UNITED STATES PATENT AND TRADEMARK OFFICE

| APPLICATION NO. | FILING DATE | FIRST NAMED INVENTOR | ATTORNEY DOCKET NO. | CONFIRMATION NO. |
|-----------------|-------------|----------------------|---------------------|------------------|
| 09/531,735 | 03/21/2000 | Shalom Levin | EPLC/03 | 7129 |

Office Action Summary

DETAILED ACTION

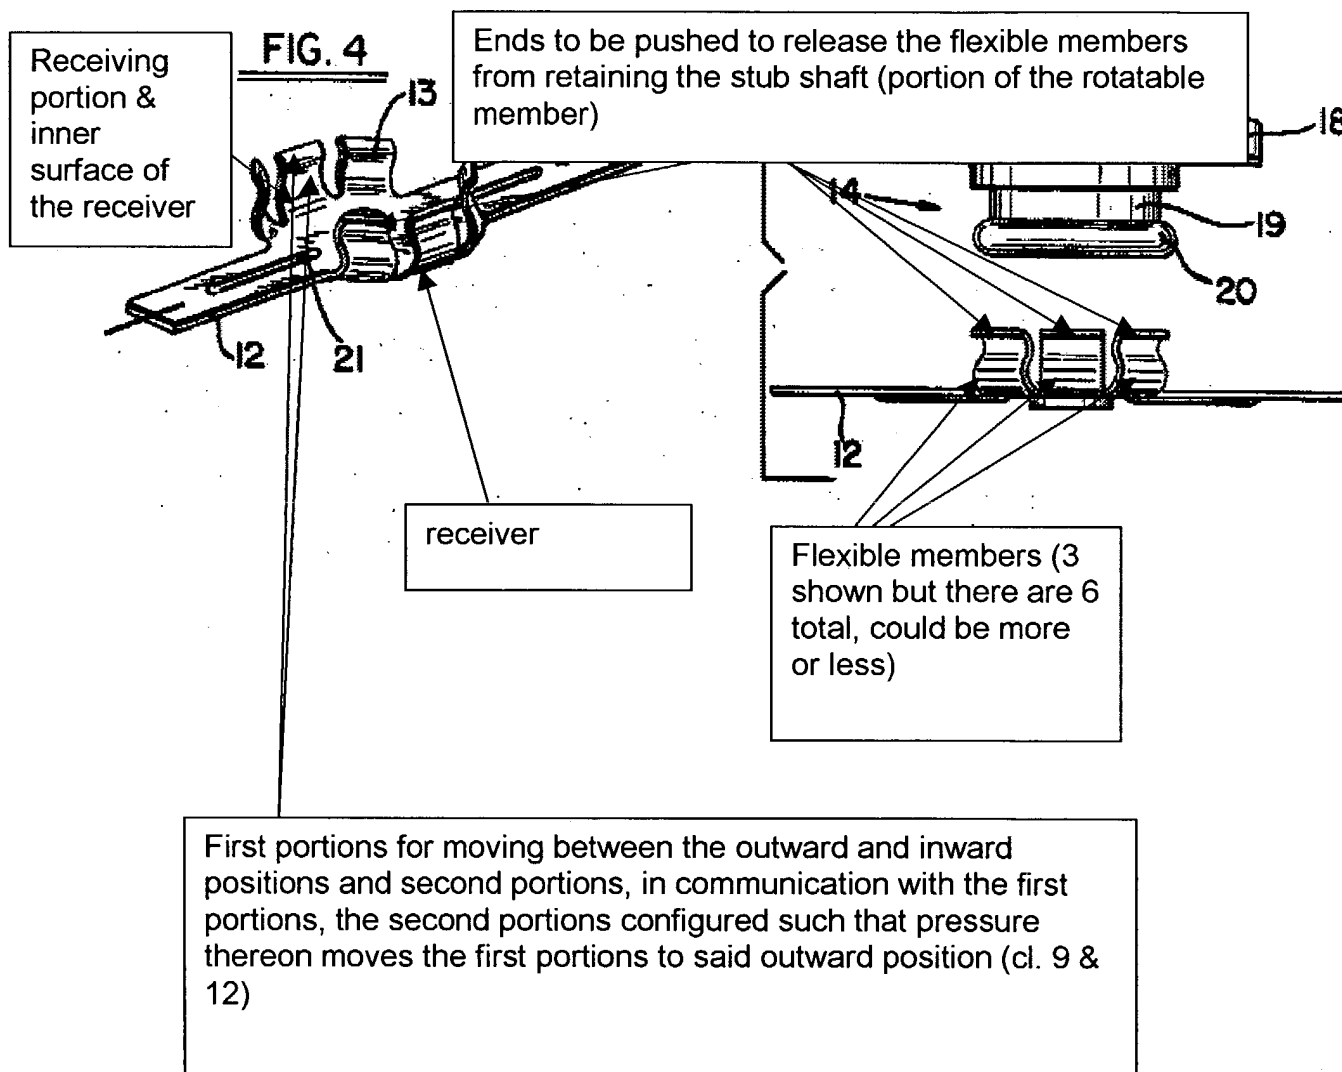
In re independent claims 9 & 12, Weber discloses as also shown in the marked up figures below, a lawnmower blade assembly comprising:

a shaft (15) configured to be rotatable with a motor (10);

a stub (19, 20) in communication with the shaft (fig 2);

a blade (12);

a receiver (22) coupled to the blade (fig 4, 5), the receiver including a receiving portion (13) and at least a plurality of flexible members (13) configured for moving between outward and inward positions for engaging and retaining the stub in the receiving portion (fig 2) in a releasable engagement, the flexible members ends configured such that pressure thereon moves the flexible members outward, allowing for at least the disengagement of the blade from the stub (as the top ends of flexible members of the receiving portion is moved outwardly the receiver is released from the stub shaft);

in re claim 10, the shaft, stub, blade, receiver are coaxial (see fig 2);

in re claim 11, the outer surface of the stub where the receiving portions's inner surface engages allows a sufficient but minimal amount of rotation play for the blade (see fig 2, the receiving portions on the outer surface of the shaft at ref 19, allows minimal rotation since it is not secured to the stub shaft, but rather pressure of the receiving portions keeps it engaged with the shaft);

a blade body (12) including oppositely disposed cutting portions (fig 6, blade 12 having oppositely disposed cutting portions) and a platform intermediate the cutting portions (as best shown on fig 4, the receiver is placed between the oppositely disposed cutting portions or in the middle of ref 12);

a receiver (22) coupled coaxially to the blade (fig 4, 5), the receiver including a receiving portion (13) and at least a plurality of flexible members (13) configured for moving between outward and inward positions for engaging and retaining the stub in the receiving portion (fig 2) in a releasable engagement, the flexible members including ends configured such that pressure thereon moves the flexible members outward, allowing for at least the disengagement of the blade from the stub (as the top ends of flexible members of the receiving portion is moved outwardly the receiver is released from the stub shaft);

Applicant's argument on page 6, 3rd paragraph, appears to recite that Applicant's "said ends in communication with said engaging portions" should be interpreted differently since the Applicant stated, that Weber's "ends and inwardly curved portions of the spring clips 13 are the same structure, and not in any way in an operative relationship with each other." It is unclear how Applicant's structural difference as maybe suggested in the Applicant's arguments would be recited in claims 9, and 12, since currently the following is recited in the claims: "ends in communication with said engaging portions" and this feature is clearly shown as marked up the drawings above, and the ends are in clear communication with the engaging portions.
